NINE MILE POINT NUCLEAR STATION

TITLE: DRYWELL COOLING SYSTEM

ATTACHMENT 6
LESSON PLAN TEMPORARY/PUBLICATION/ADDENDUM CHANGE FORM

Modification Title: Ductwork and Air Flow Changes for 2DRS-UC1A through 1D

FIGURE 9.4-8)

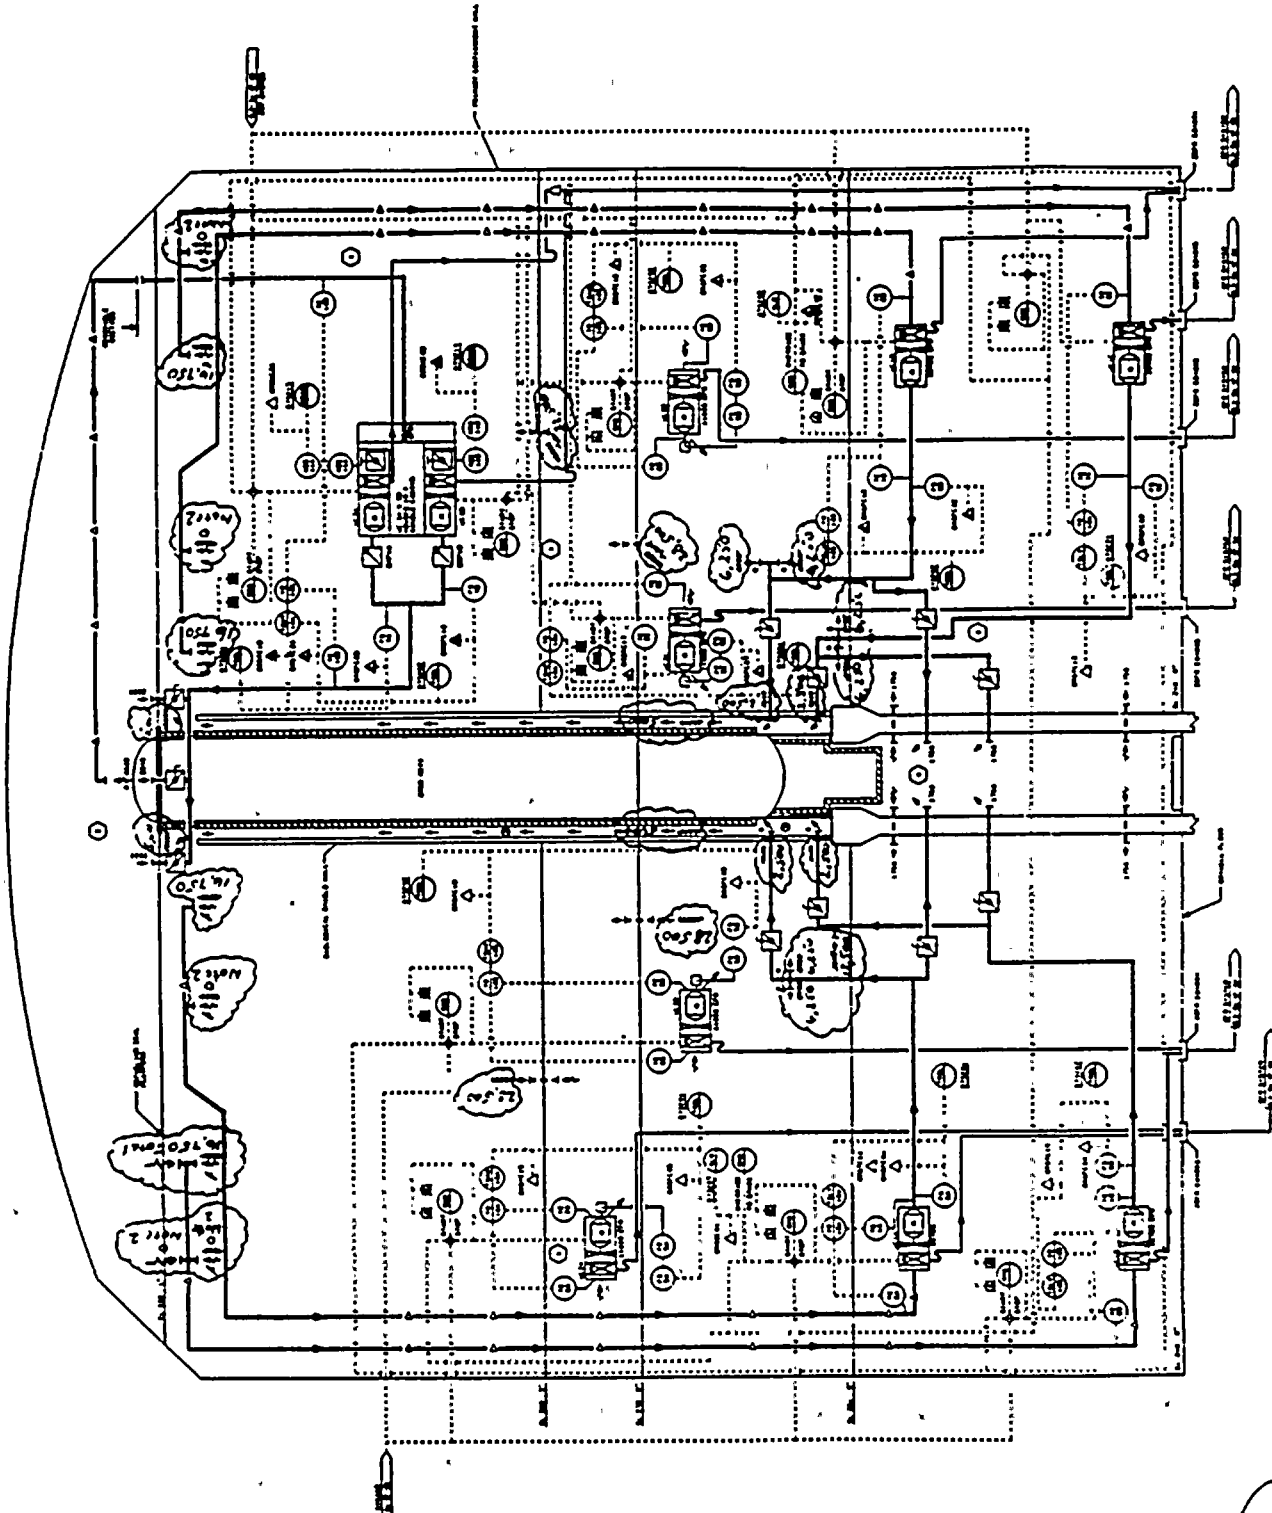
1. Four unit coolers are located on el. 240 ft and serve to cool the RPV control rod drive area, the RPV skirt, and the general drywell areas on el 240 ft and 261 ft. Return air to the unit coolers is ducted from the general drywell areas ~~at~~ ~~el 288 ft 3 in and~~ above el 316 ft.
2. Four unit coolers are located on el 278 ft 6 in and serve to cool the general drywell areas on the same elevation. Supply and return air is nonducted.
3. Two unit coolers are located on el 288 ft 3 in and discharge through a common supply air duct to cool the RPV top head area. Return air from the same area is transmitted through a common return air duct to both unit coolers.

- CONFIDENTIAL - SECURITY INFORMATION
- Blank off register to allow no air flow
1. Blank off register to allow no air flow
 2. Blank off register to allow no air flow
 3. Blank off register to allow no air flow
 4. Blank off register to allow no air flow
 5. Blank off register to allow no air flow
 6. Blank off register to allow no air flow
 7. Blank off register to allow no air flow
 8. Blank off register to allow no air flow
 9. Blank off register to allow no air flow
 10. Blank off register to allow no air flow

FIGURE 9.4-9

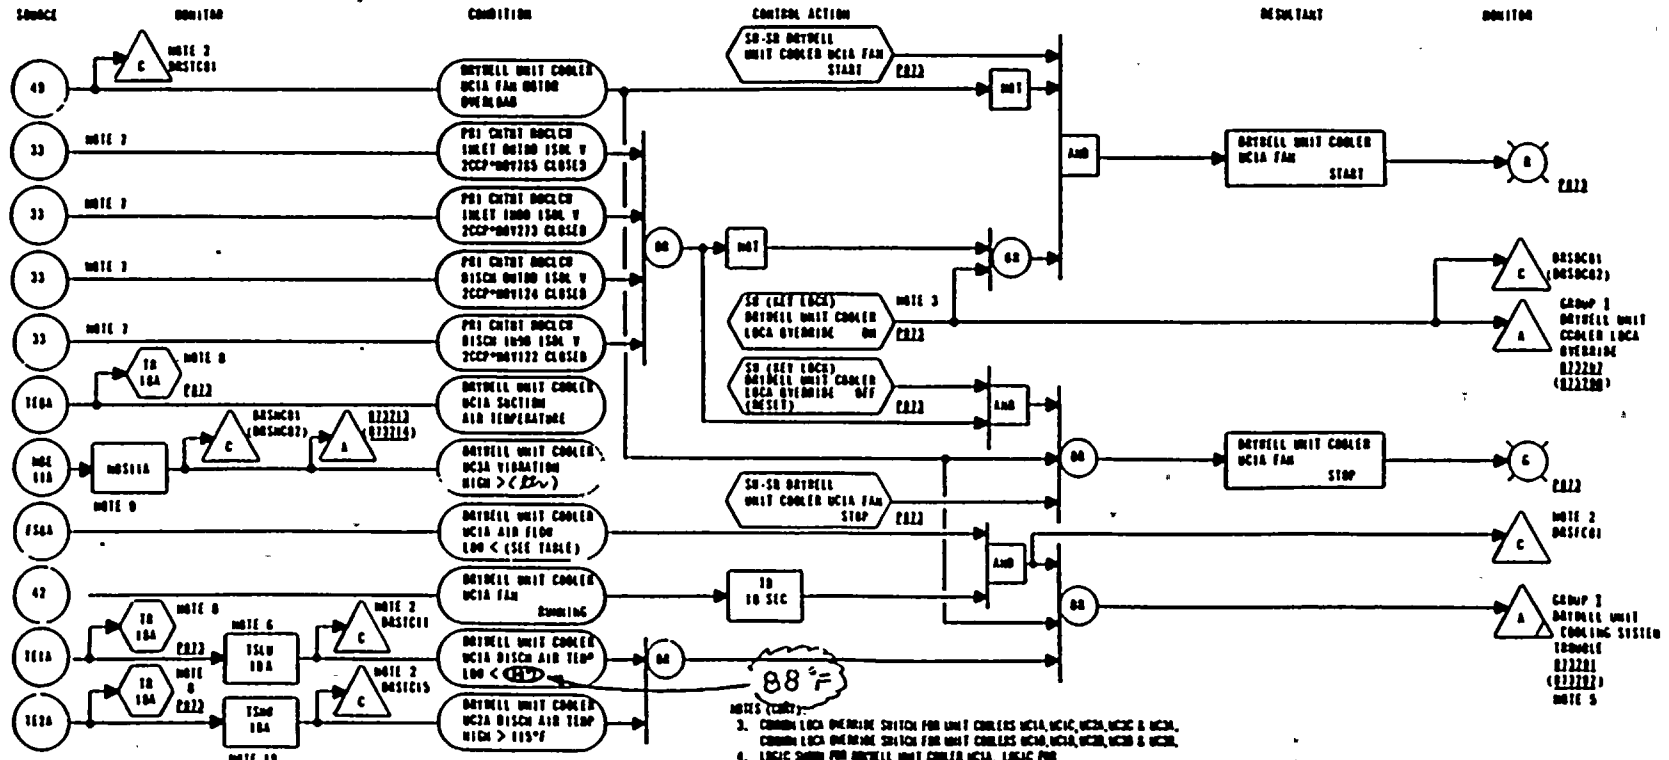
5- Revise set point for Low UC 1A, B, C & D discharge air temp from 100°F to 98°F

DOCUMENT NUMBERS IMPACTED FSK-22-22B

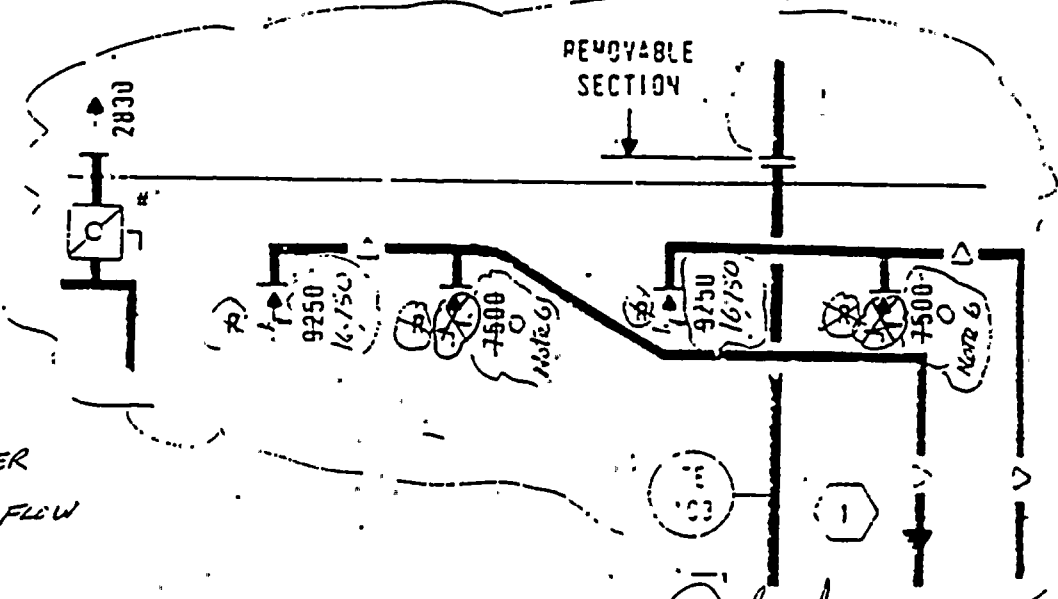
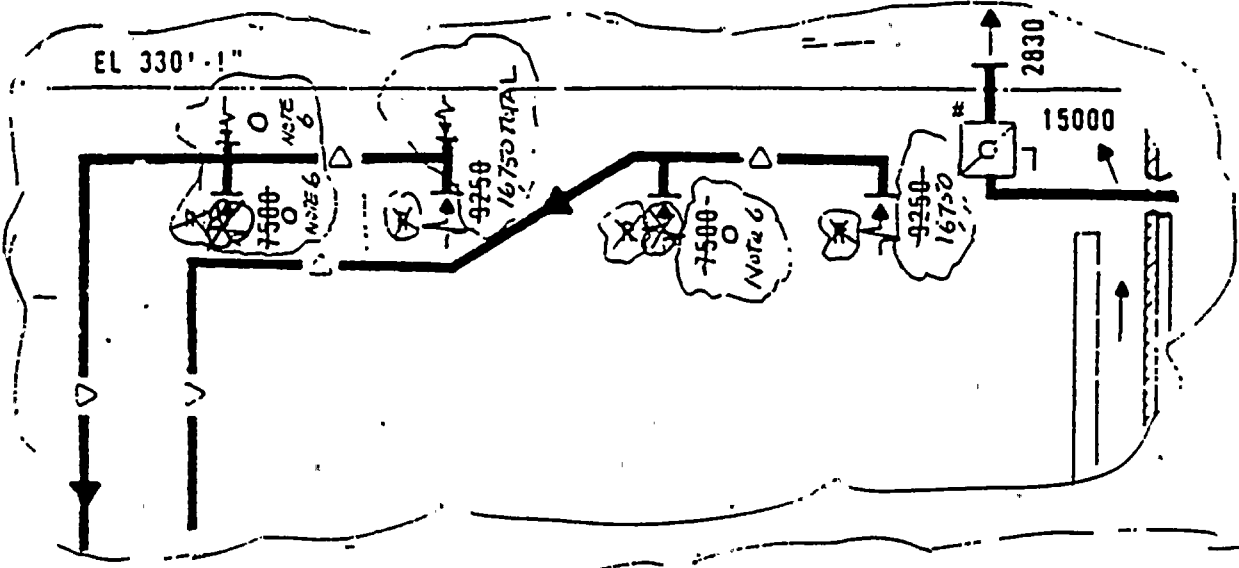
REVISE FSK-22-22B to blank off one out of two return air registers of unit coolers 1A, 1B, 1C & 1D and remove the register from the other duct openings (NEL 325). See the following sketches. Also add note 6.

NOTE 6: BLANK OFF REGISTER
TO ALLOW NO AIR FLOW

FSK-22-22A

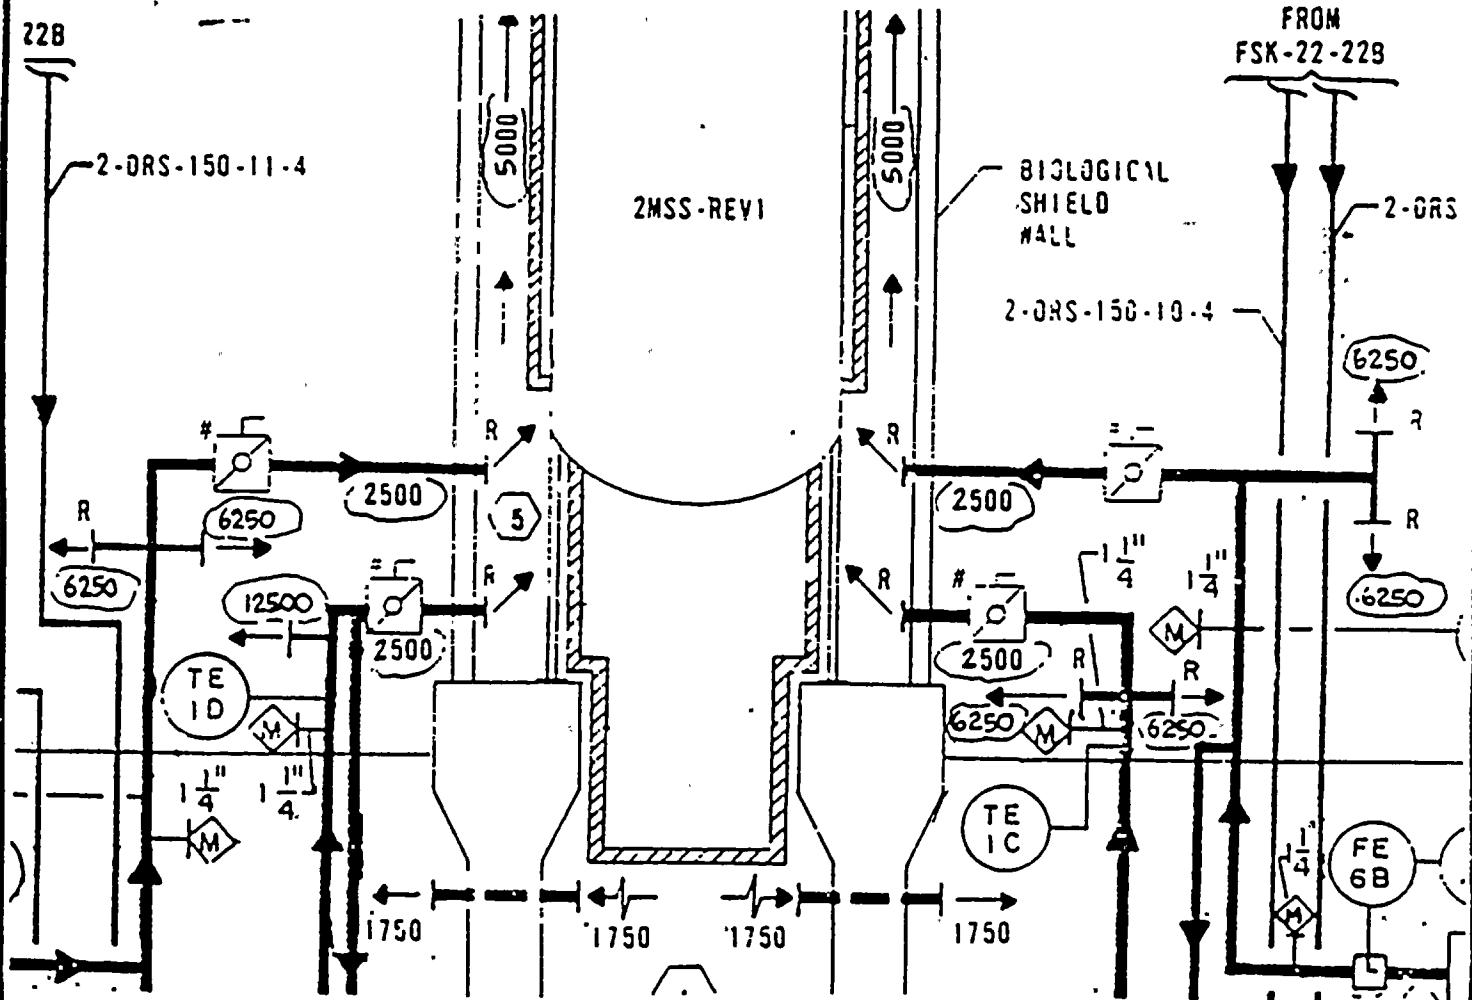
1) REVISE FSK-22-22A AS FOLLOWS:
 (ZONES E-M / 2-6)

FSK-22-22B Addendum A (CONT)

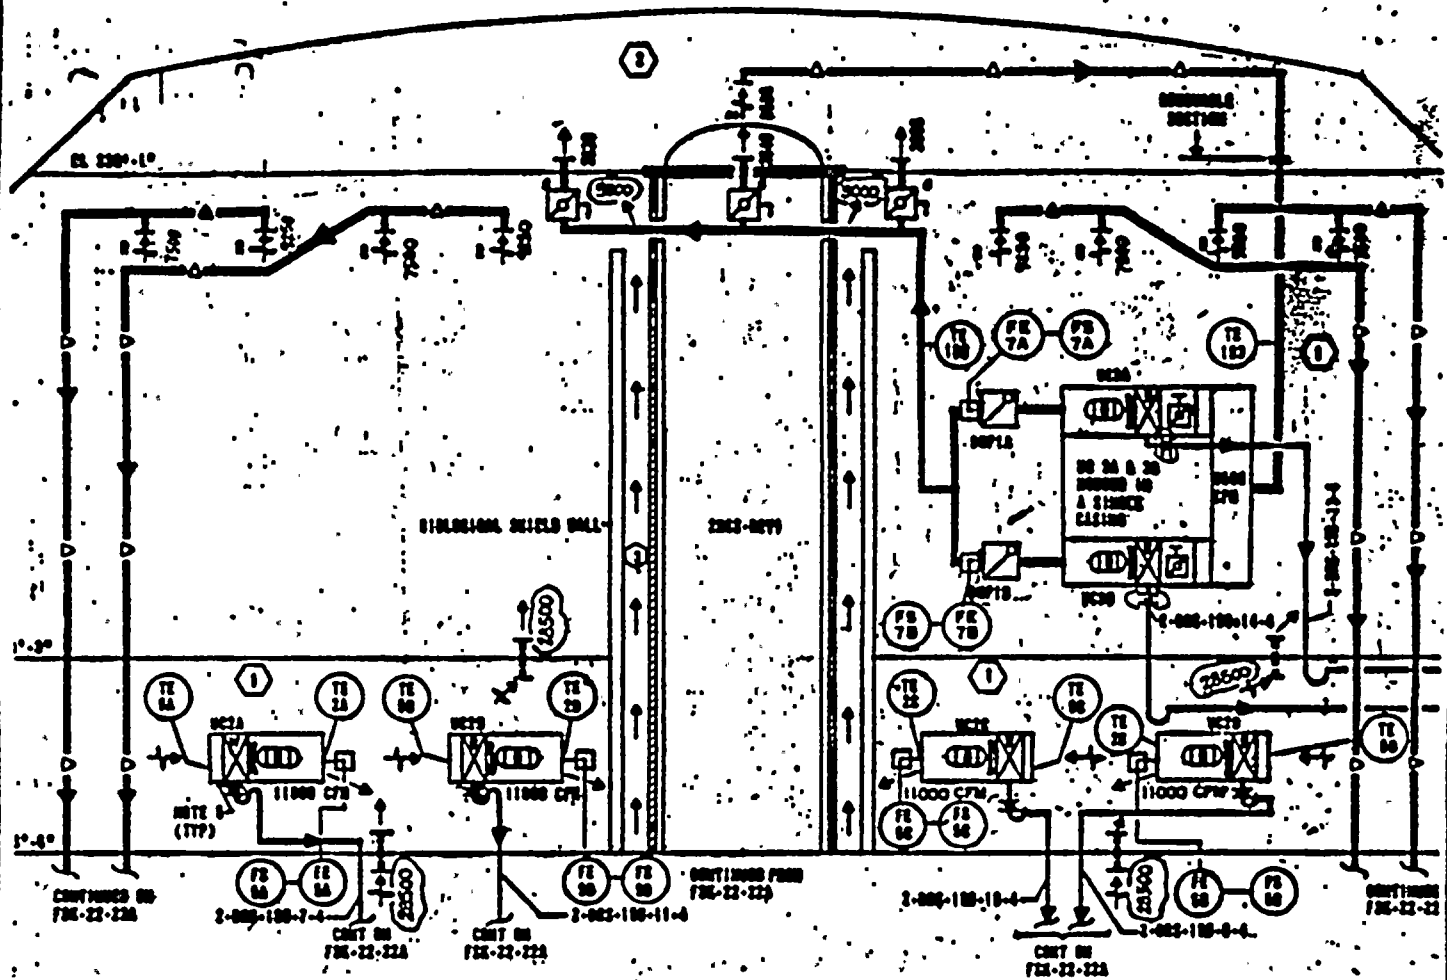
2) Revise FSK-22-22B (ZONES E-Q/2-9) AS FOLLOWS:

P&ID 60A Addendum A (cont)

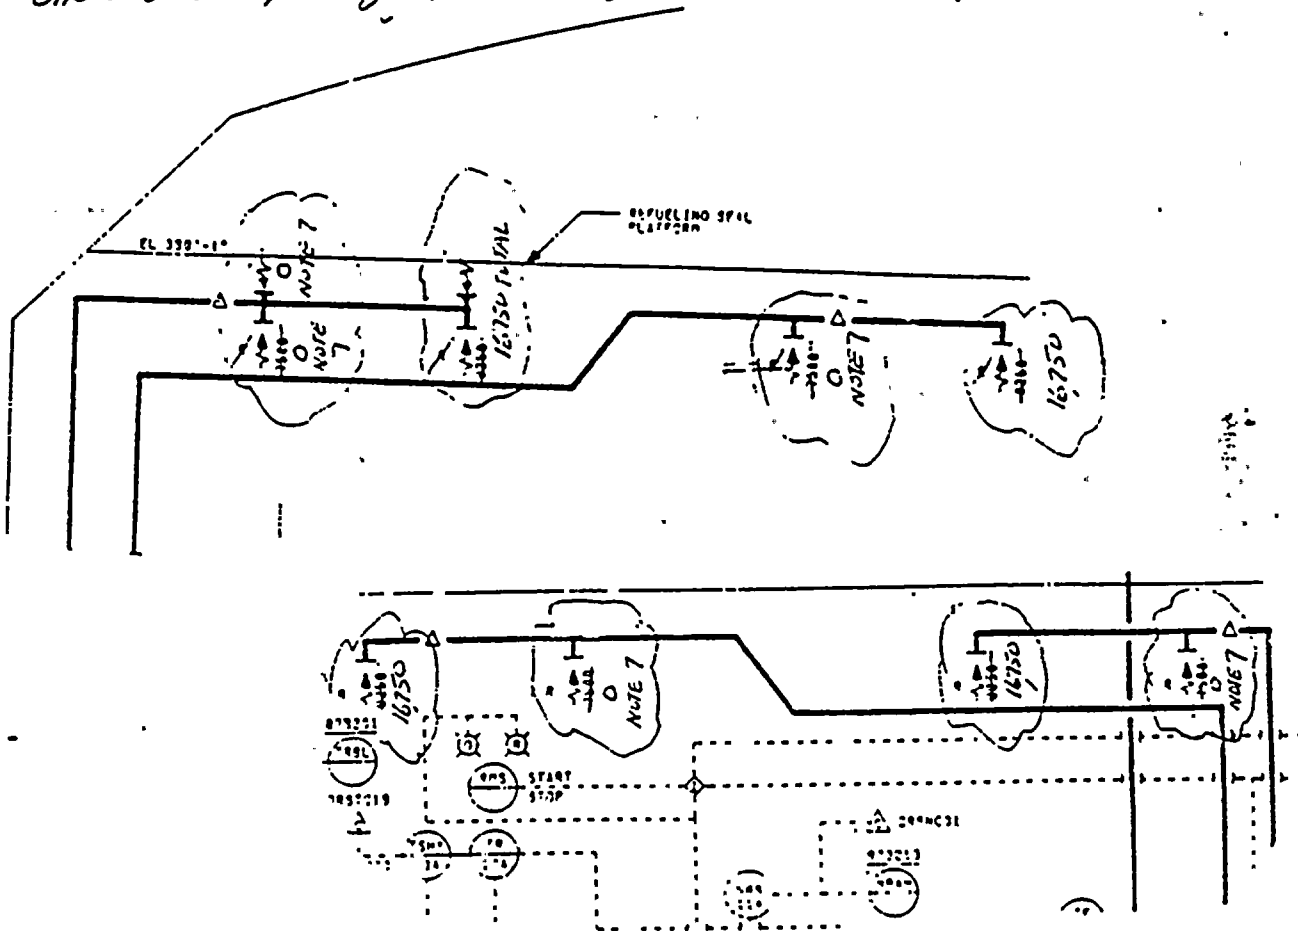
Revise P&ID-60A to blank off one out of two return air registers of unit coolers 1A, 1B, 1C & 1D and remove the register from the other duct openings (EL. ~ 320'). Also add note 7

NOTE 7: Blank OFF REGISTER TO ALLOW NO AIR FLOW

PID-60A Addendum A (CONT)

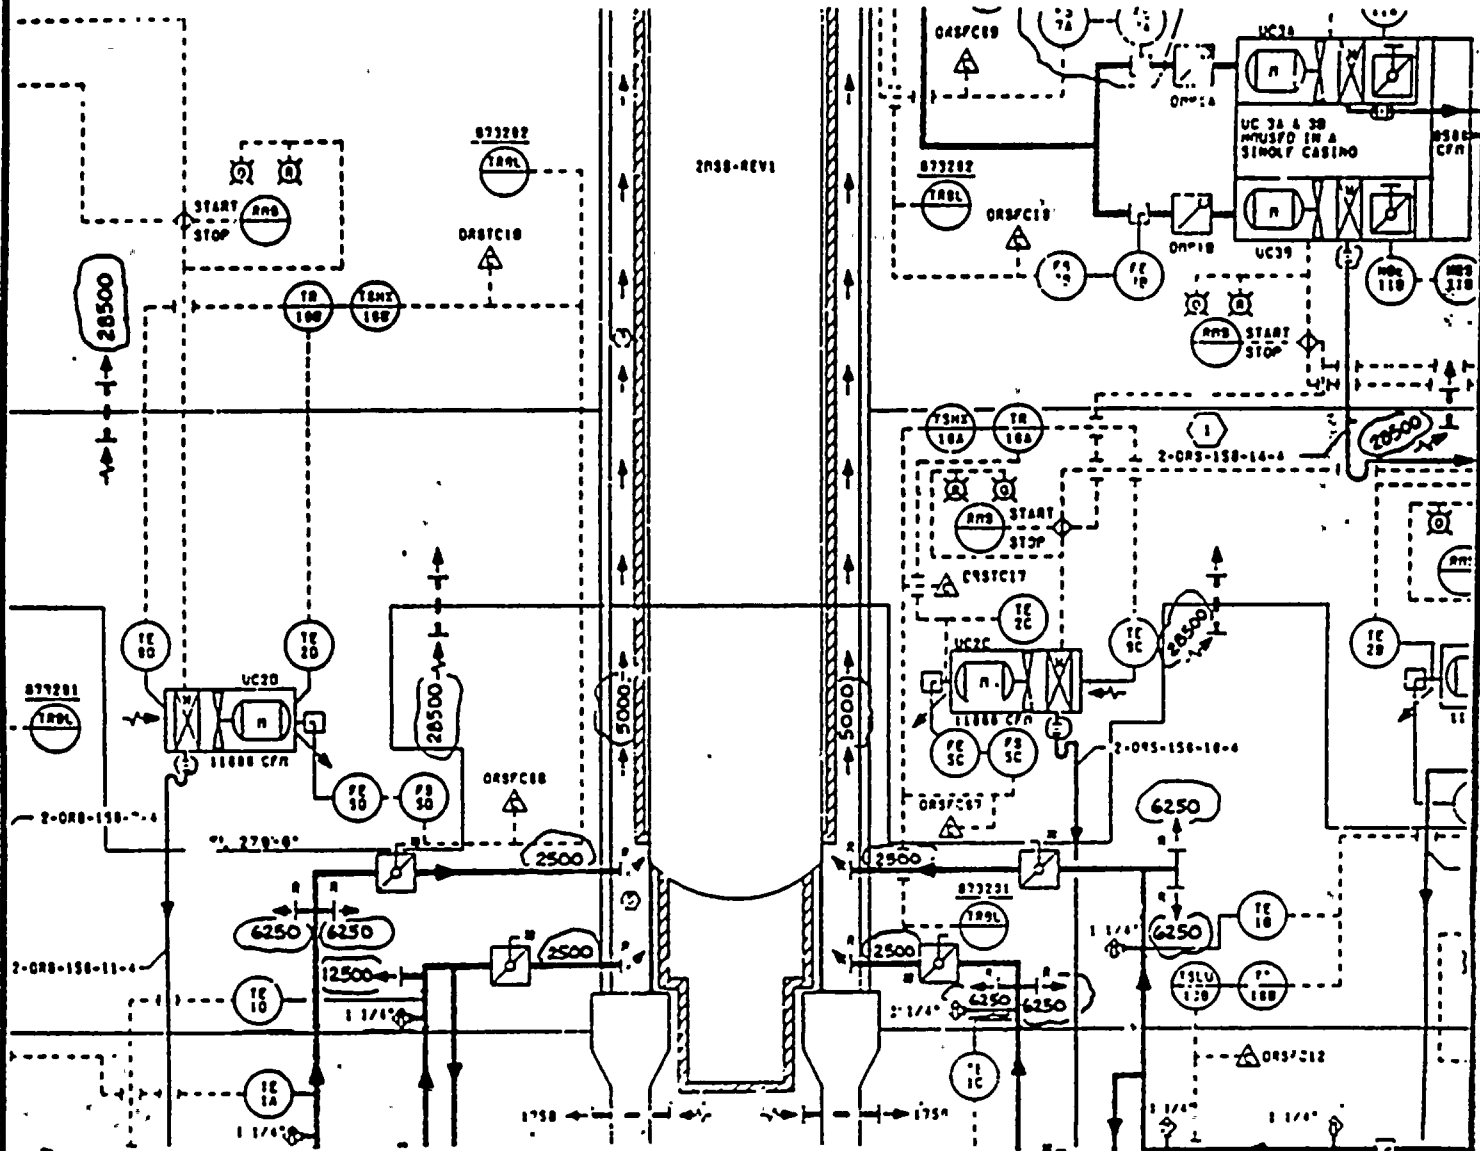
Revise PID-60A (D-H/4.7) AS FOLLOWS:

PID-60A Addendum A' (cont)

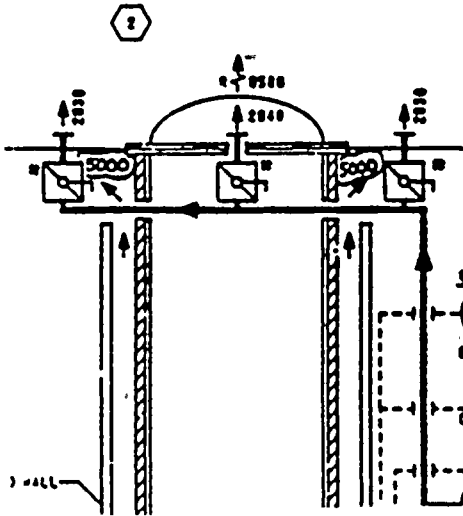
Revise PID-60A (G-3)
